Redevelopment of Mandurah Marina, lot 11, Old Coast Road, Mandurah

Norman Hope Nominees Pty Ltd

**Report and recommendations
of the Environmental Protection Authority**

**Environmental Protection Authority
Perth, Western Australia
Bulletin 692
July 1993**

Figure 2: Map of vegetation and existing foreshore reserves

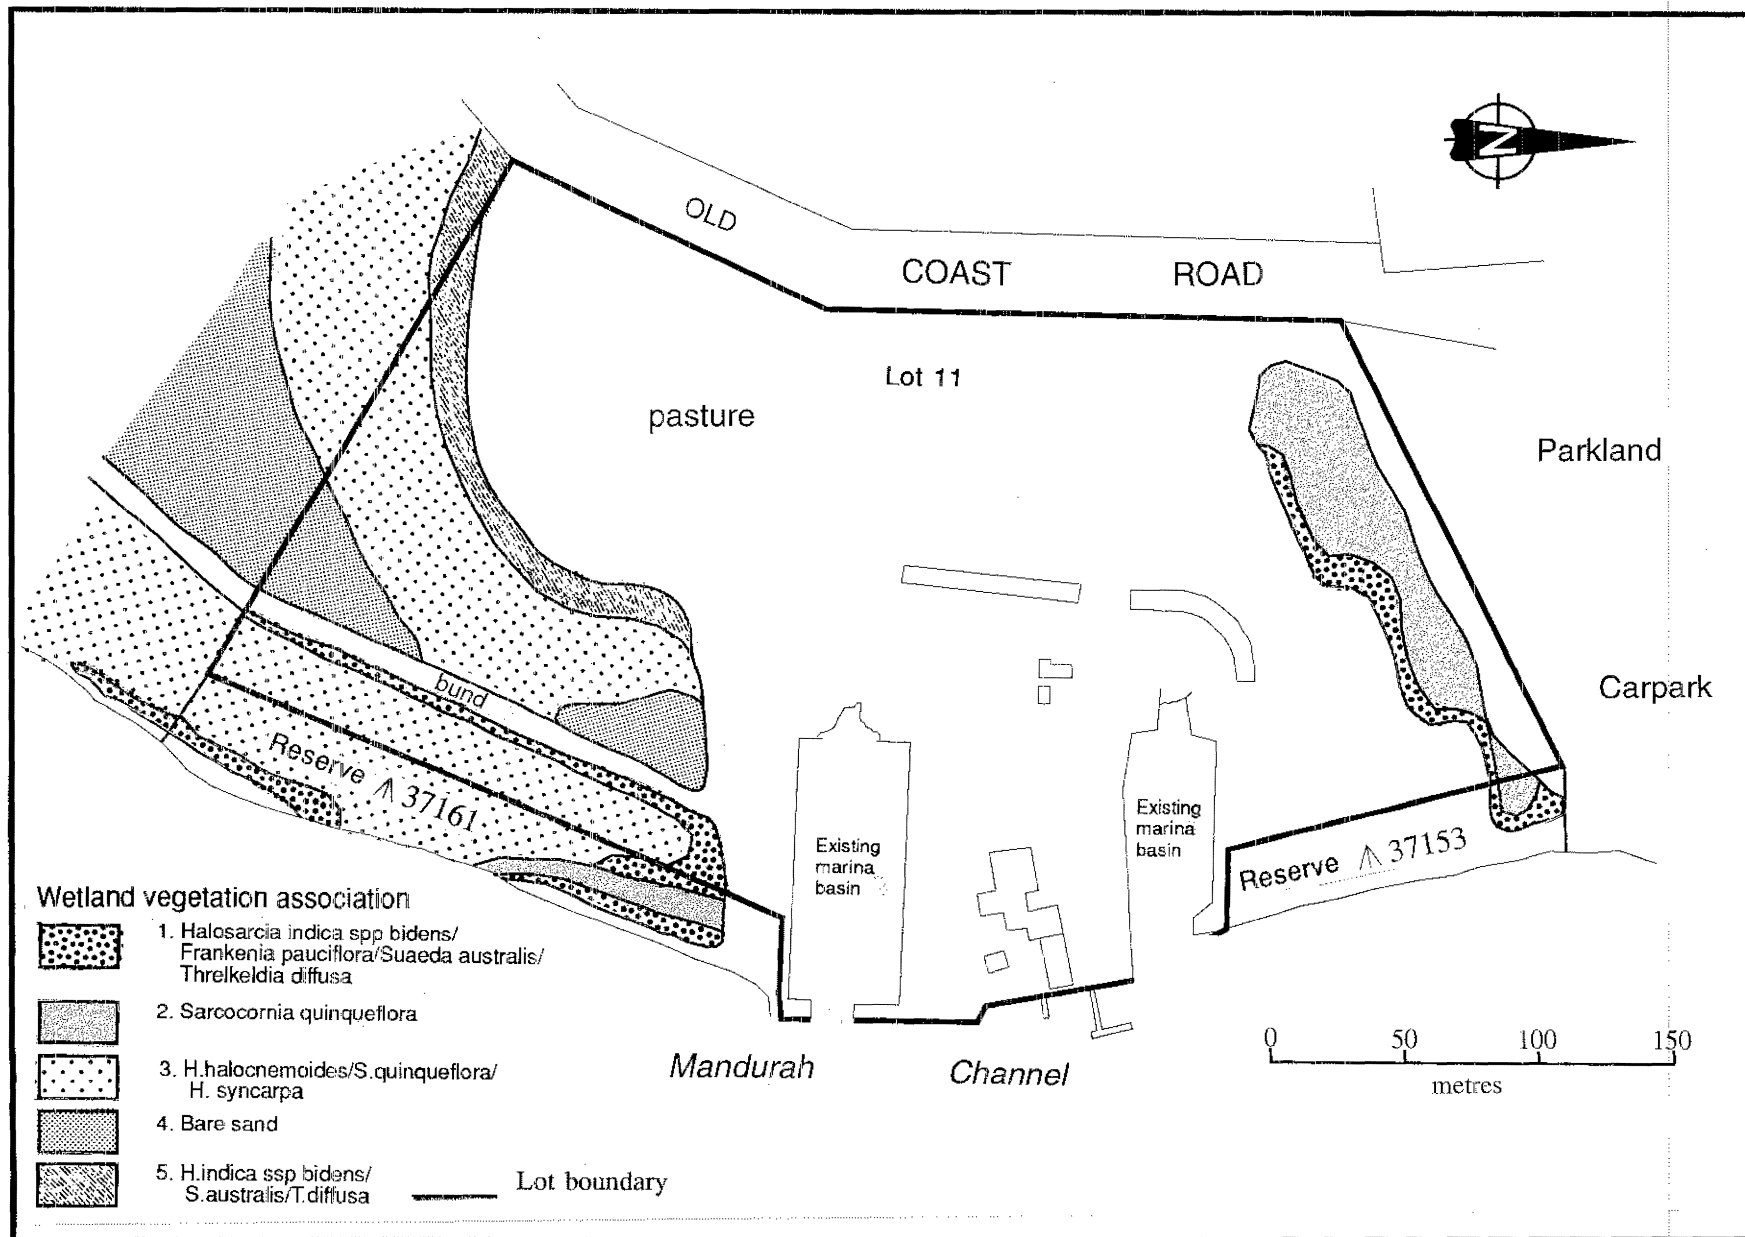
The proposed development would cause the loss of 2.24 ha of samphire wetland. The area to be filled would include the tidal drainage basin at the northern end of the site and a portion of the southern samphire area (Figure 2). The northernmost wetland is surrounded by a park, pasture, a major road and the Mandurah Channel. The wetland has been used for stormwater discharge and there has been some weed invasion. Despite the pressures of the surrounding land uses, this wetland has a high species diversity of samphire, provides valuable wildlife habitat and is the area closest to the channel entrance of these samphire species in the Mandurah townsite.

Figure 1: Wetland area referred to in Recommended Environmental Condition 3-2.

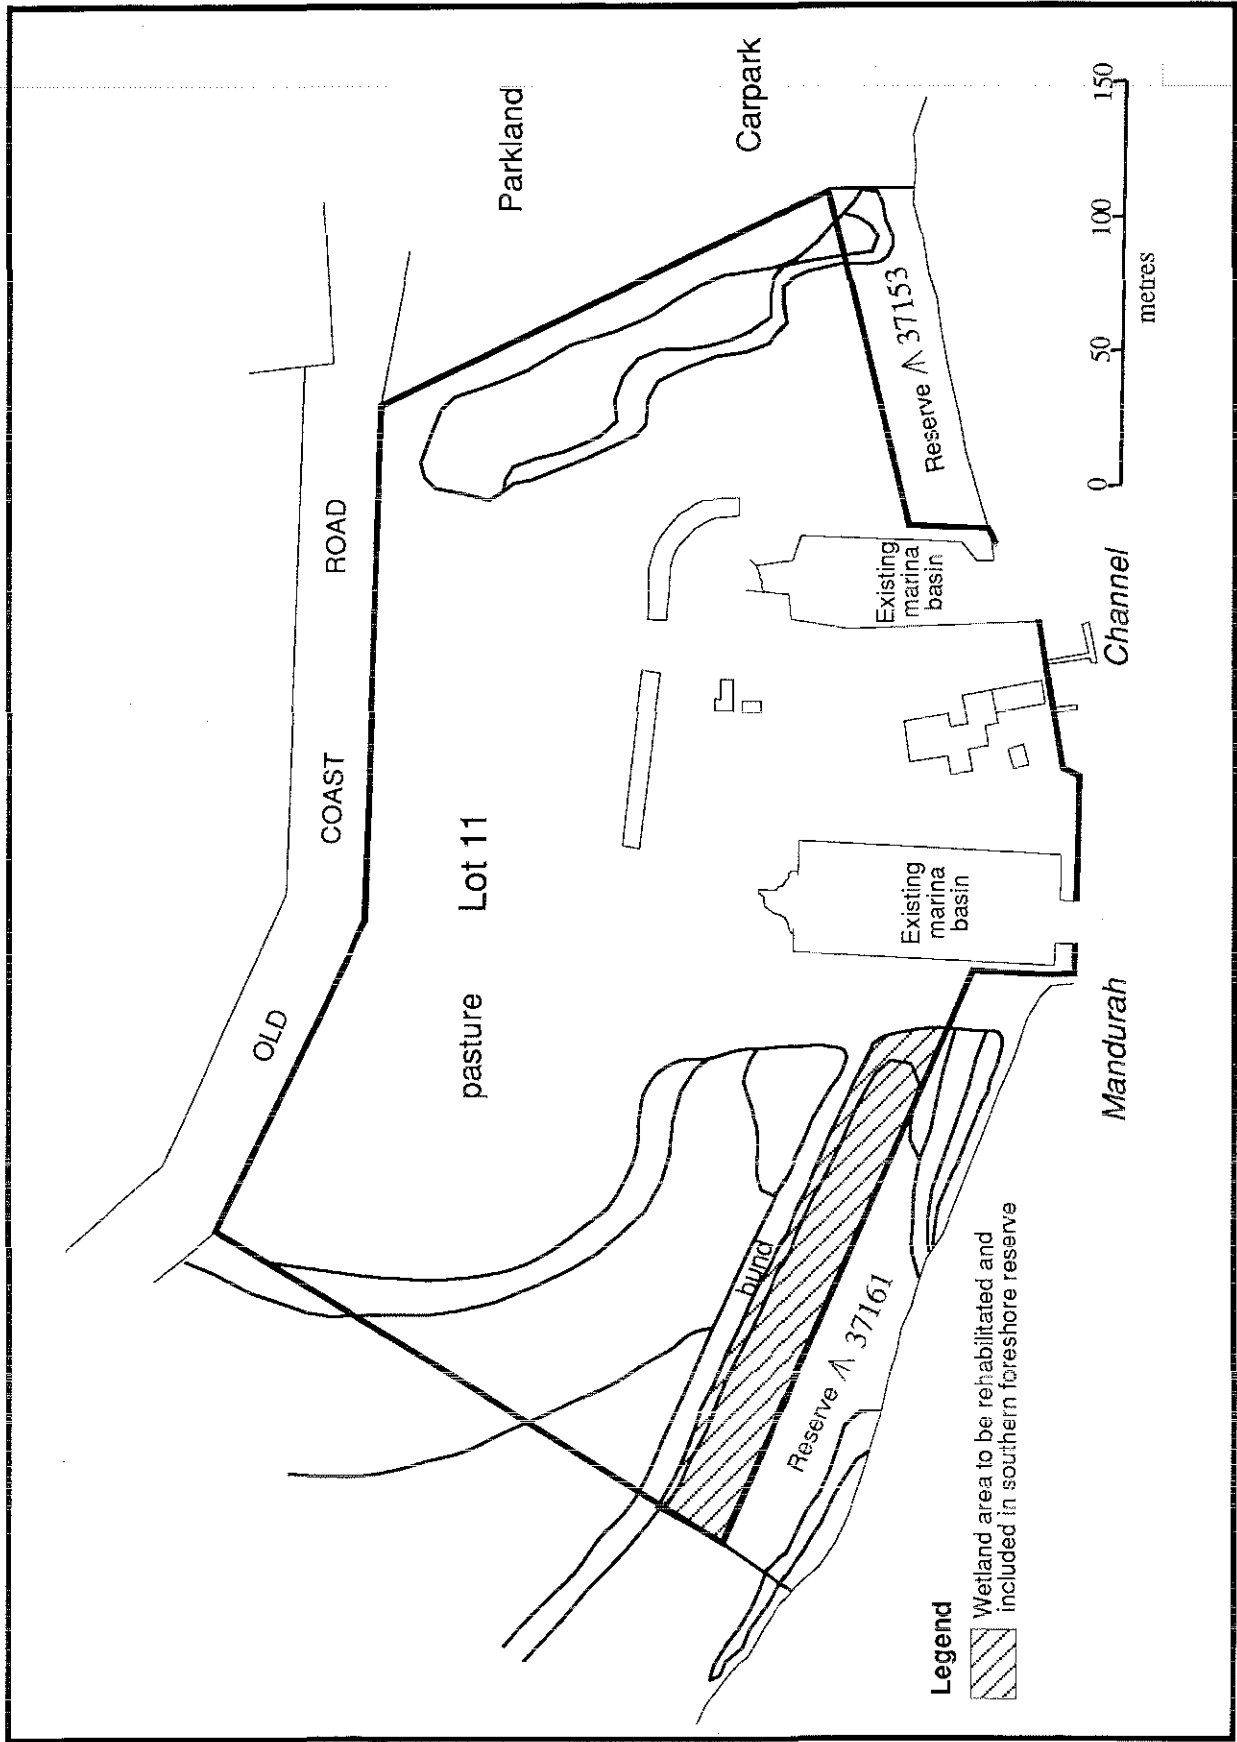
- 3-2 The proponent shall rehabilitate the southern wetland area, as shown on Figure 1, between the existing bund and the Mandurah Channel to the requirements of the Environmental Protection Authority on advice of the Peel Inlet Management Authority.
